2 Type of change

3 Detailed description of change

| Product Change Notification | | | | | PCN SWA | | |
| owner | creation date | release date | released by | change order no | rev | page | D10-011-722 |

Label adjustment:

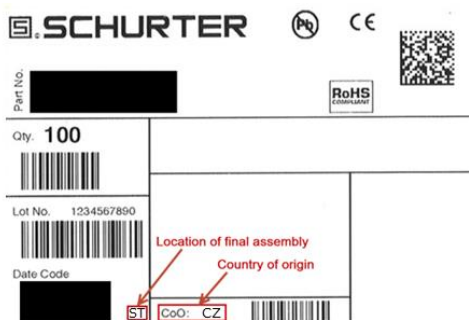
The location of final assembly and the country of origin of various voltage selector has changed from Switzerland to Czech Republic.

Label Yes Modified label for change of location of final assembly and country of origin
 Packaging No No change in packaging
